Staff Report

To: Salt Lake City Historic Landmark Commission
From: Aiden Lillie, Senior Planner, aiden.lillie@slcgov.com
Date: June 1, 2023
Re: PLNHLC2023-00350 Alteration to a Contributing Structure

Major Alteration

PROPERTY ADDRESS: 1454 E Harvard Avenue
PARCEL ID: 16-09-352-007-0000
MASTER PLAN: East Bench Master Plan
ZONING DISTRICT: H (Historic Preservation Overlay) 21A.34.020,
R-1-7000 (Single-Family Residential) 21A.24.060, & YCI (Yalecrest
Compatible Infill Overlay District) 21A.34.120
DESIGN GUIDELINES: Residential Design Guidelines

Proposed Roof Plans, May 4, 2023

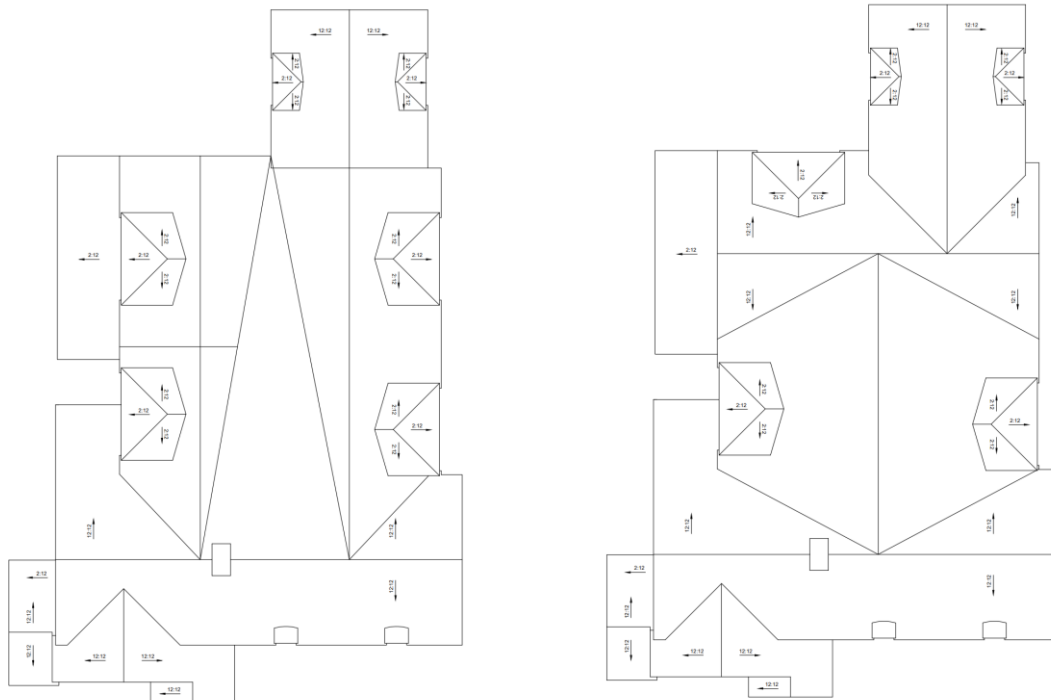
On May 4, 2023, staff met with the applicant again to discuss the proposed roof plan and proposed west elevation. The applicant identified two potential roof plans for the addition. Plan A allowed for a portion of the historic rear wing's roof form to remain, however, potential drainage issues with this plan. Plan B included the removal of the rear wing's roof form and is the current roof plan for the proposal.
